SUNDRY NOTICES AND REPORTS ON WELLS
Do not use this form for proposals to drill or to re-enter an abandoned well. Use form 3160-3 (APD) for such proposals.

WORKOVER PROCEDURE

OXY USA Inc.
OXY 33 FEDERAL #1
30-015-28970

OXY 33 Federal 1
30-015-28970
OXY USA WTP LP
July 22, 2013
Conditions of Approval

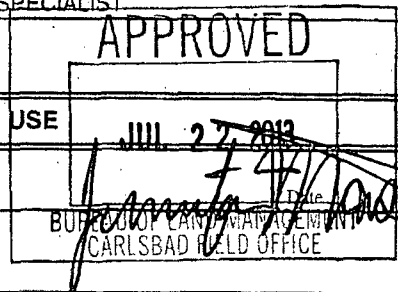
Operator is approved for completion in the Strawn formation ONLY.

1. Before plugging and abandoning the Strawn formation, operator shall submit a sundry to plug the top of the Morrow formation.
2. Before casing or a liner is added or replaced, prior BLM approval of the design is required. Use notice of intent Form 3160-5.

6. Operator to have H2S monitoring equipment on location.
7. A minimum of a 3000 (3M) BOP to be used. All blowout preventer (BOP) and related equipment (BOPE) shall comply with reasonable well control requirements. A two ram system with a blind ram and a pipe ram designed for the size of the work string shall be adequate. Tapered work strings will require an additional pipe ram. The manifold shall comply with Onshore Oil and Gas Order #2 Attachment I (3M Diagrams of Choke Manifold Equipment). The accumulator system shall have an immediately available power source to close the rams and retain 200 psi above pre-charge. The pre-charge test shall follow requirements in Onshore Order #2.

8. Subsequent sundry required detailing work done and completion report for the new formation. Operator to include well bore schematic of current well condition when work is complete.
